F8267D-15F

Modification Available Performance Enhancement Service Note

E8267D Analog Signal Generator

Instrument failing self-test 704

System Update

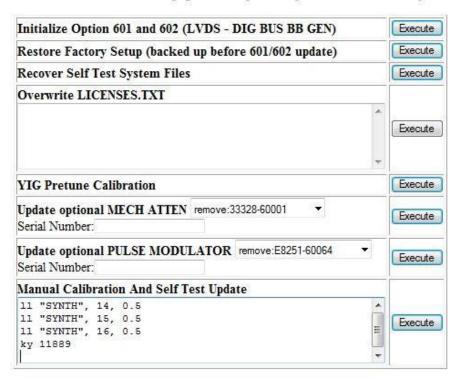
The self-test limits for A6 Frac-N have been updated to avoid possible faulty self-test failure 704. This applies for all instruments including units with Special Handling options HCC and HAR.

- 9. Open a browser window and type in the instrument IP address/update (http://xxx.xxx.xxx/update)
- 10. Then enter the following text into the 'Manual Calibration And Self-Test Update' box.

Il "SYNTH", 14, 0.5 Il "SYNTH", 15, 0.5 Il "SYNTH", 16, 0.5 ky 11889

- 11. Press 'Execute' button next to the 'Manual Calibration And Self Test Update'.
- 12. When the update is completed, another webpage will be displayed with the message 'Operation completed'. To finish, power cycle the instrument and verify the limits have been updated using steps 1-3 above.
